AGENDA
DESIGN COMMISSION
Community Room, 3rd Floor
Arlington Heights Village Hall, 33 S. Arlington Heights Rd.
Arlington Heights, IL 60005
September 9, 2025
6:30 PM

Design Commission
9/9/2025

Item: 210 S. Mitchell Ave. - SF/Teardown - DC25-064

STAFF DESIGN COMMISSION REPORT

CONTEXT ELEVATION FRONT
(EAST)-PROPOSED
① 1/8" = 1'-0"

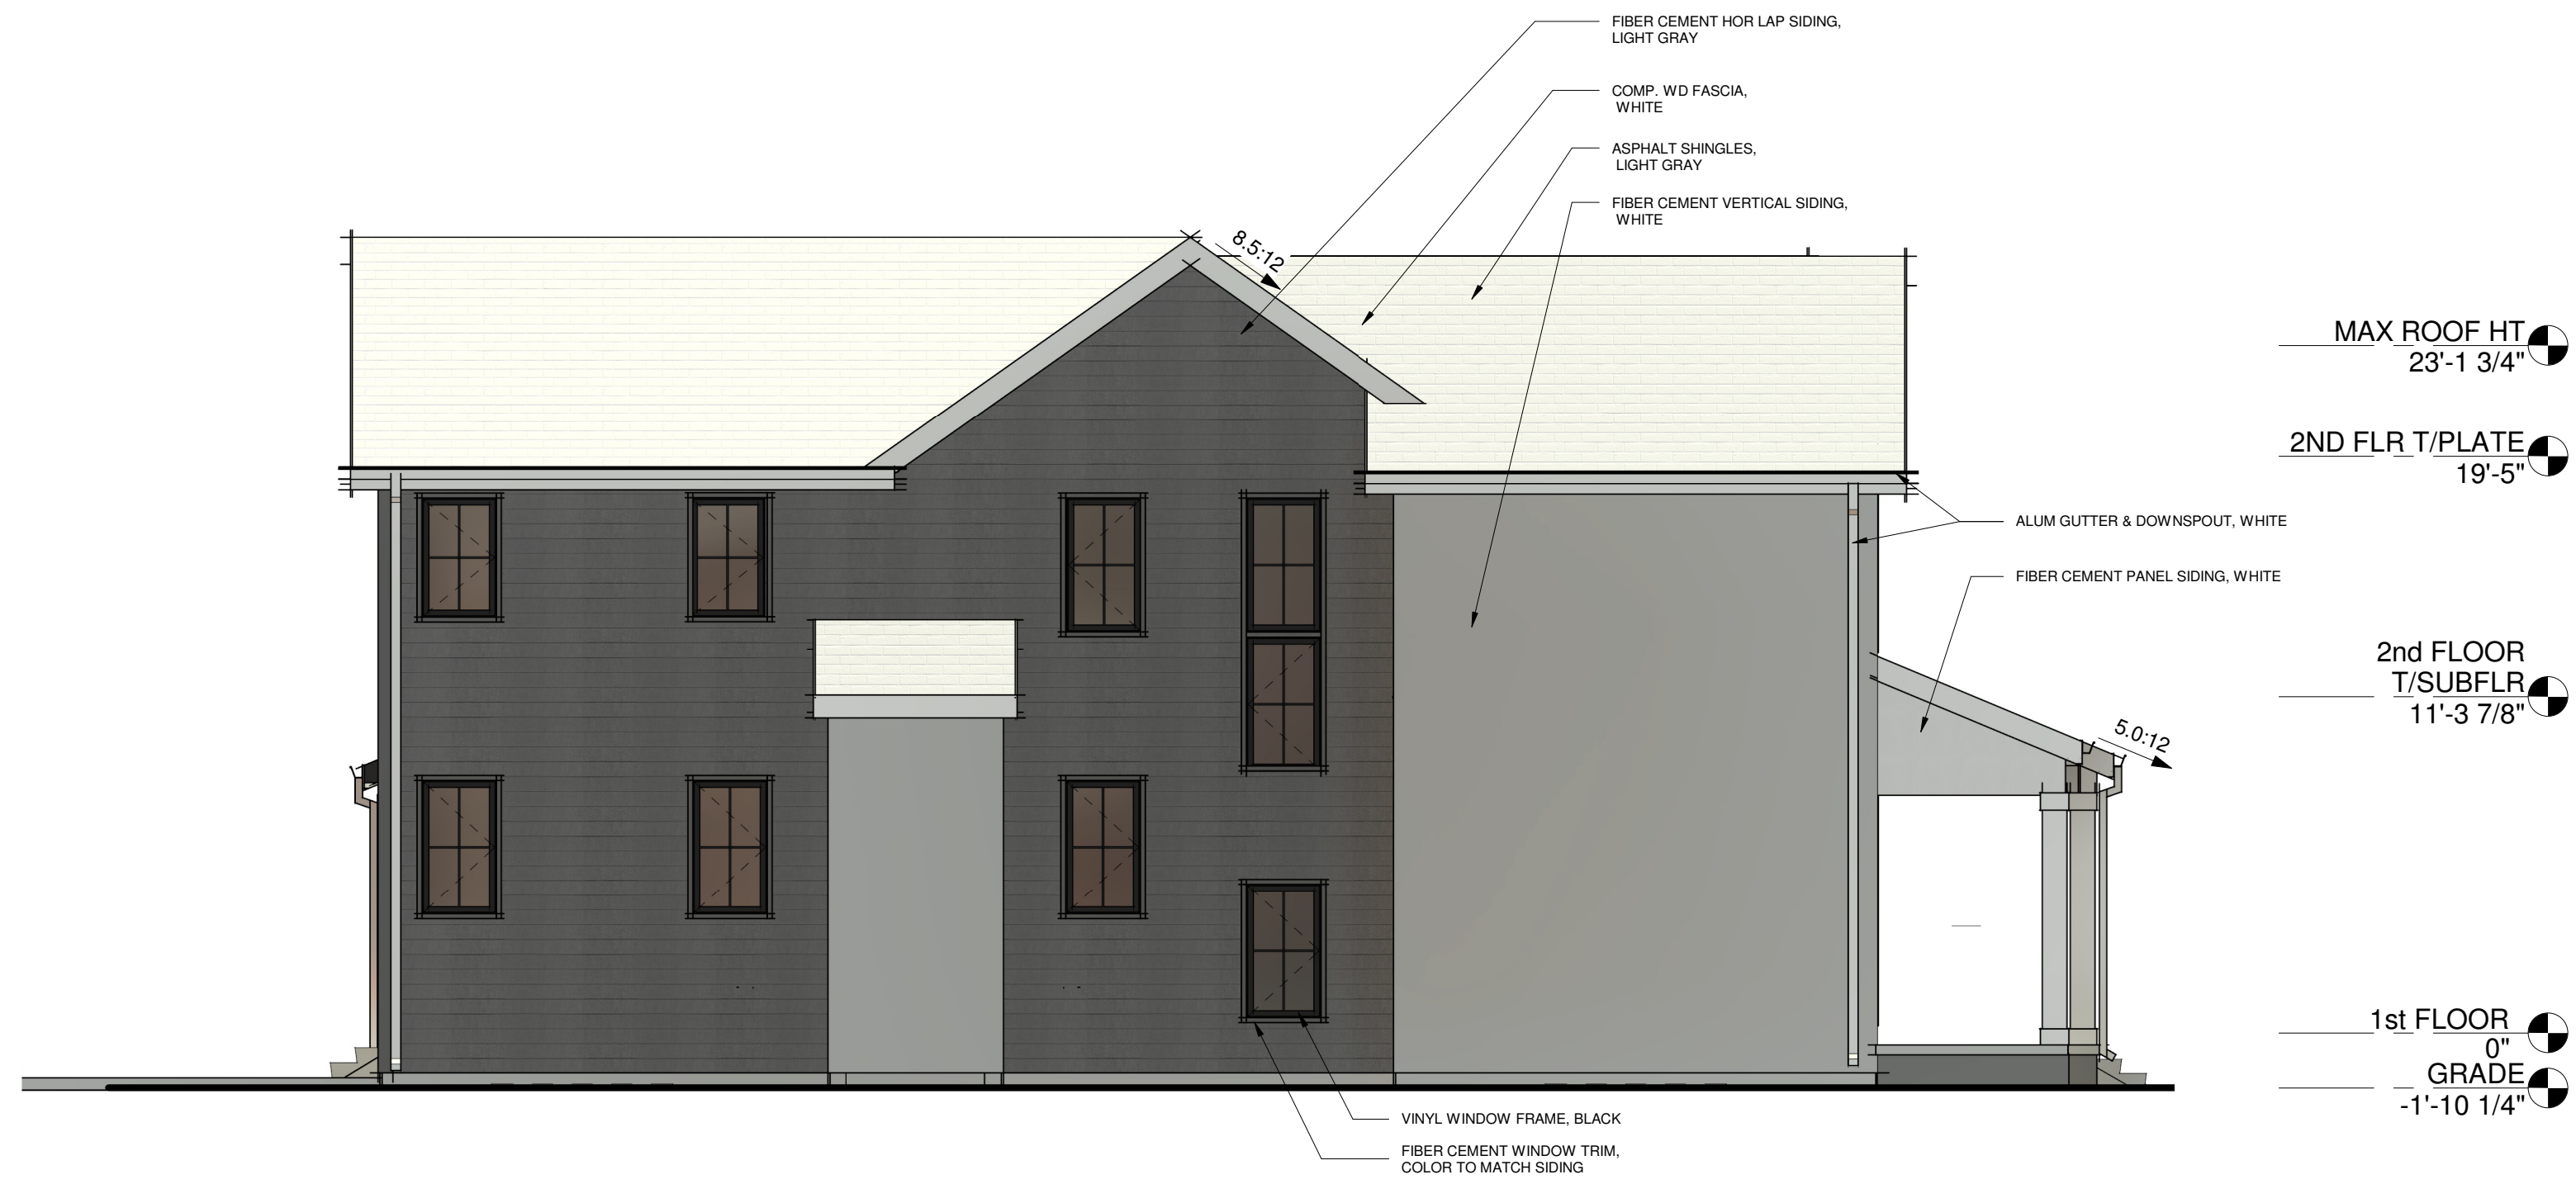
The existing house (proposed for demolition) is a historic, craftsman, bungalow-style home located on a block that is comprised of predominantly other similar historic bungalows and cape cod style homes with detached garages. However, there are two newer two-story homes with attached garages on the block. One of those new homes was built on a vacant lot, and the other was a teardown of an architecturally insignificant house.

In regards to the proposed new house, one of the purposes of the Village of Arlington Heights' Single-Family Design Guidelines is to evaluate how the proposed home fits with the character of the existing neighborhood. In this case, the proposed new house with prominent front load attached garage and only one step up to the

front porch does not fit with the existing context. If the Design Commission does not object to demolition of the existing house, then Staff recommends that the proposed new house should be redesigned to better fit with the character of the neighborhood with a one-and-a-half story massing, a raised front porch, a detached garage, or a recessed attached garage.

2. If the Design Commission does not object to demolition of the existing house, then to comply with the Village of Arlington Heights' Design Guidelines, the proposed new house should be redesigned to better fit with the character of the neighborhood with a one-and-a-half story massing, a raised front porch, a detached garage, or a recessed attached garage.

LEFT SIDE ELEVATION

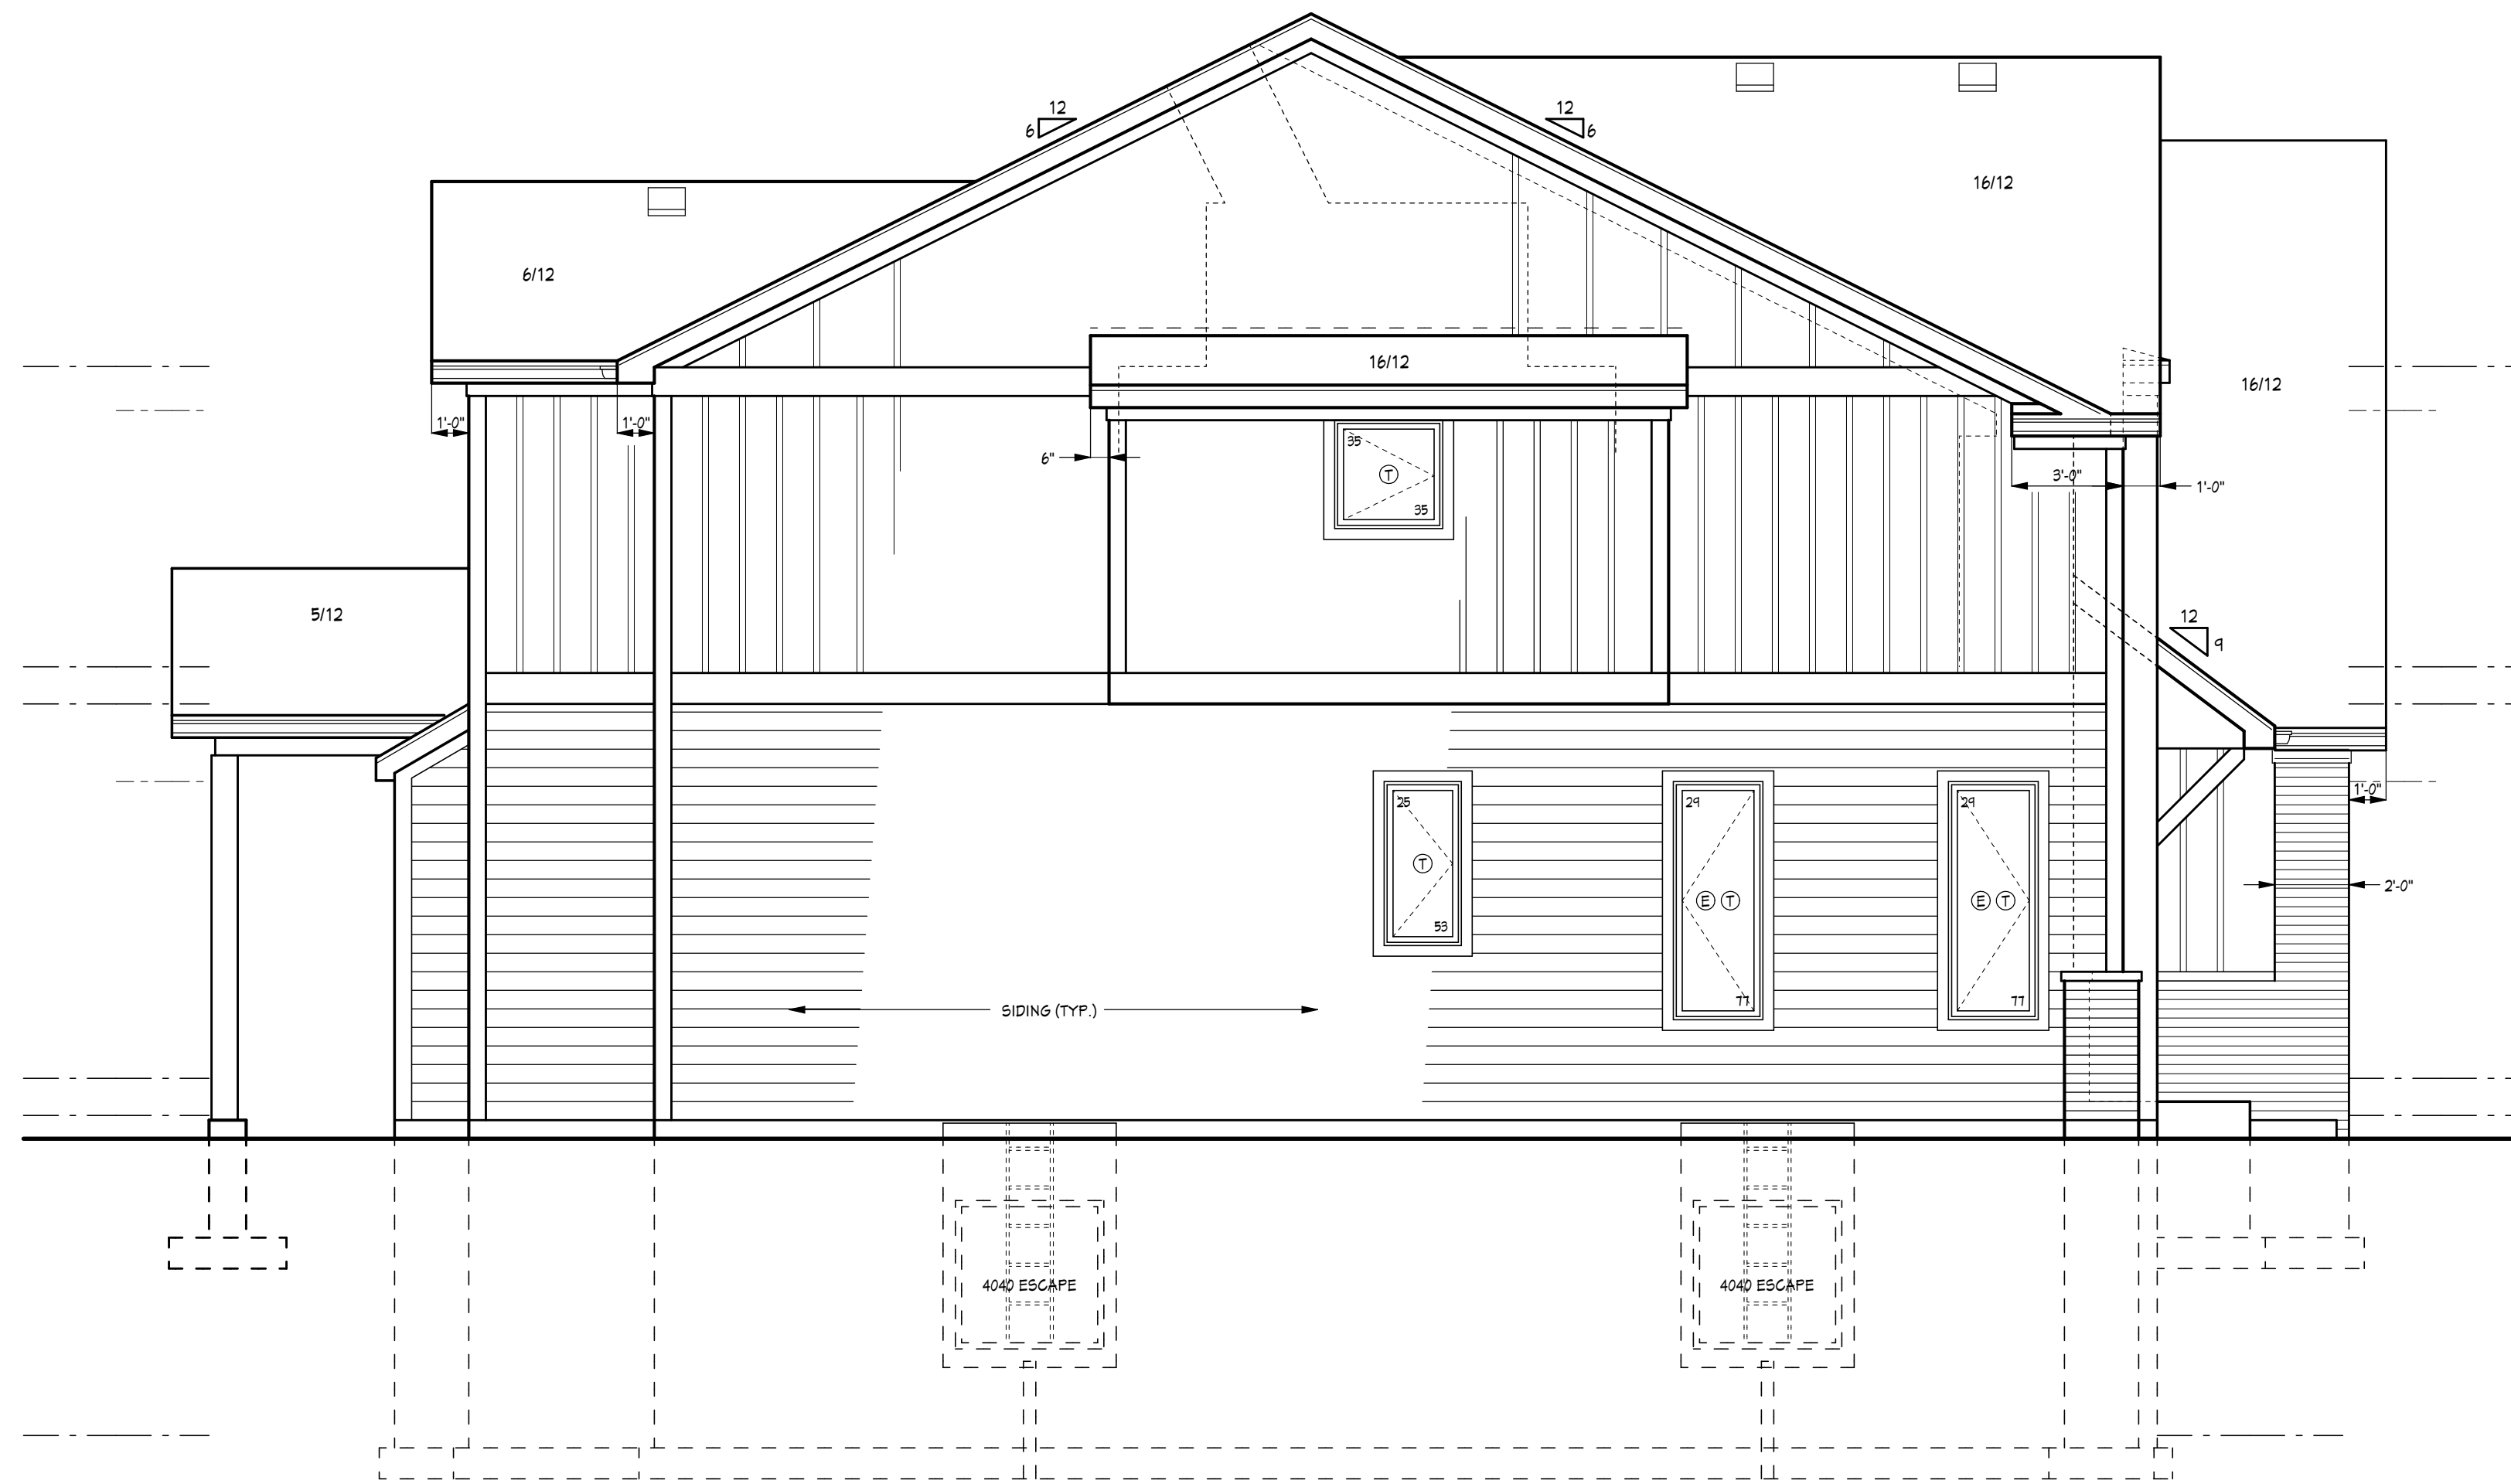
The proposed three-car garage is unusual for this neighborhood, which the Design Commission should evaluate, although it is nicely designed by stepping back the front wall. The only other comment on the design is that the blank gable wall above the garage has an unusual and somewhat odd appearance which the Design Commission should also evaluate
